UNITED STATES PATENT AND TRADEMARK OFFICE

APPLICATION NO.	FILING DATE	FIRST NAMED INVENTOR	ATTORNEY DOCKET NO.	CONFIRMATION NO.
10/737,345	12/16/2003	Andrew Niemczyk	1504-P3005.001	6020

Office Action Summary	Application No. 10/737,345	Applicant(s) NIEMCZYK, ANDREW	
	Examiner William V. Gilbert	Art Unit 3635

DETAILED ACTION

Figure 2 from Rose

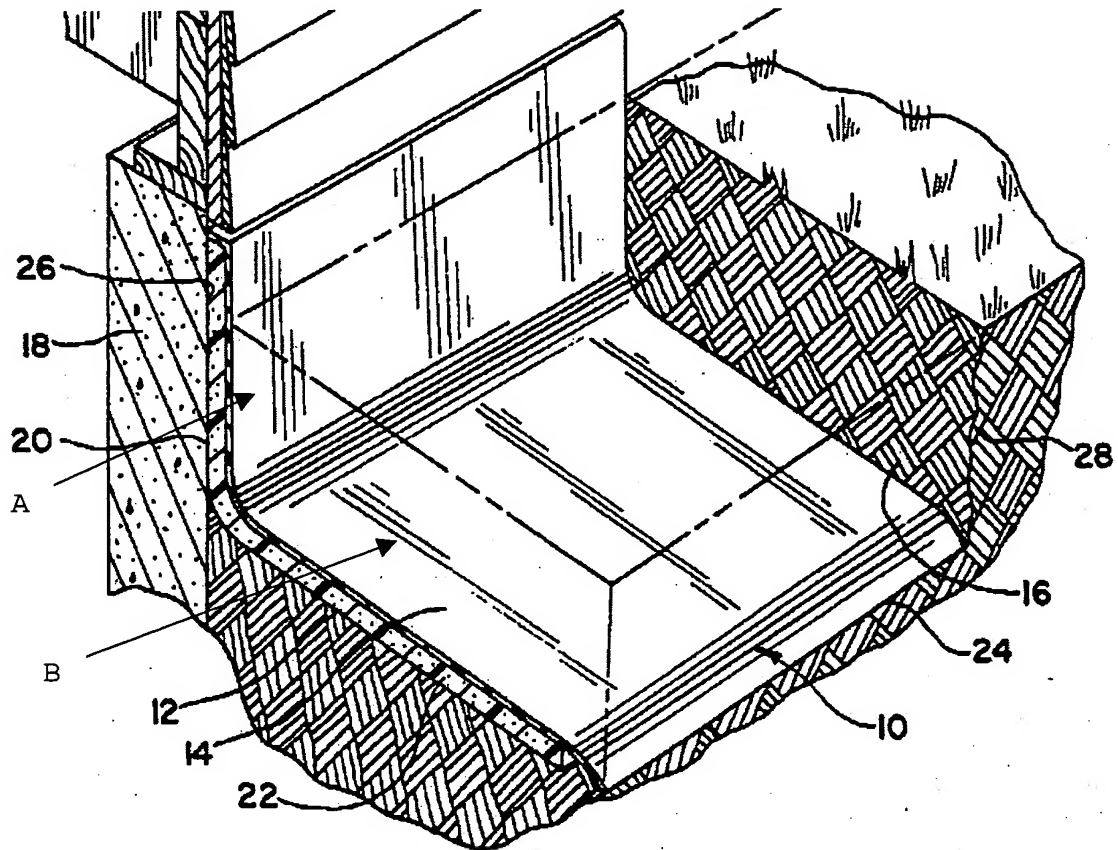
digging ground to form a trench (on the exterior side of the basement wall) with the trench wide enough to receive a semi-flexible member (Column 7, lines 52-60; See Figure 2), placing overlapping water impermeable semi-flexible members (Figure 5, elements 10a, 10b, 10c, 10d; Column 4, lines 29-32) in the trench with a short leg (see element "A" from attached Figure 2 from Rose below) of each member (abutting against the basement wall) and having a long leg (see element "B" from attached Figure 2 from Rose below) extending substantially away from the basement wall (See Figure 2, generally; see Column 8, lines 9-20), and backfilling the trench with soil above the water impermeable members (Column 8, lines 35, 36).

Regarding Claims 1 and 4, Rose discloses a basement wall water protection system (14) comprising at least one (or a plurality of, per Claim 4) water impermeable flexible member(s) (Column 2, lines 44-46; Column 4, line 43; Figure 5), having a short leg section (see "A" from attached Rose Figure 2 above) and a long leg section (see "B" from attached Rose Figure 2 above) extending away from the basement wall (see Figure 2, generally; see **Claim Rejections - 35 USC § 112** above regarding the statement about the "basement wall"), a first side edge (14a, per Claim 4) and a second side edge (14b, per Claim 4) that can join each other to form a watertight joint (Column 6, lines 49-52, per Claim 4). While Rose discloses the dimensions of the waterproof member to be approximately 4'6" by 8'6" (Column 4, lines 60-63), Rose does not disclose the long leg section extending at a calculated distance at least as great as the tangent of 15 degrees times the height of the basement wall below the impermeable flexible member (see **Claim Rejections - 35 USC § 112** above regarding the statement about the "basement wall"). It would have been obvious at the time the invention was made to a person having ordinary skill in the art to make the dimension of the long leg in Rose as calculated in the Claim because the Applicant's Specification (Page 7, paragraph 0031) states that the length of the long leg could be approximately

Regarding claim 5, Rose discloses a short leg (see "A" from attached Figure 2 from Rose, above). The phrase, "being placed below ground level and free to move against said basement wall and held against said wall solely by ground pressure" is a statement of intended use of the claimed invention and must result in a structural difference between the claimed invention and the prior art in order to patentably distinguish the claimed invention from the prior art. If the prior art structure is capable of performing the intended use, then it meets the claim.

Regarding Claim 9, Rose discloses the long leg (see "A" from attached Figure 2 from Rose, above) extending away from the basement wall at approximately a 5-degree downward slope (Column 5, lines 29-37; see Claim 11 rejection above for calculation). Regarding the phrase "extending at least approximately the height of the basement wall below the leg times the tangent of 15 degrees", see rejections of Claims 1 and 4, above; see **Claim Rejections - 35 USC § 112**).

Regarding Claim 7, the phrase "each of said member being positionable about 16 inches below ground level with the short leg member abutable against said basement wall", is a statement of intended use of the claimed invention and must result in a structural difference between the claimed invention and the prior art in order to patentably distinguish the claimed invention from the prior art. If the prior art structure is capable of performing the intended use, then it meets the claim. Here, the member (10) in Rose is capable of being placed at any depth abutable to a basement wall (see Rose Figure 2, generally).
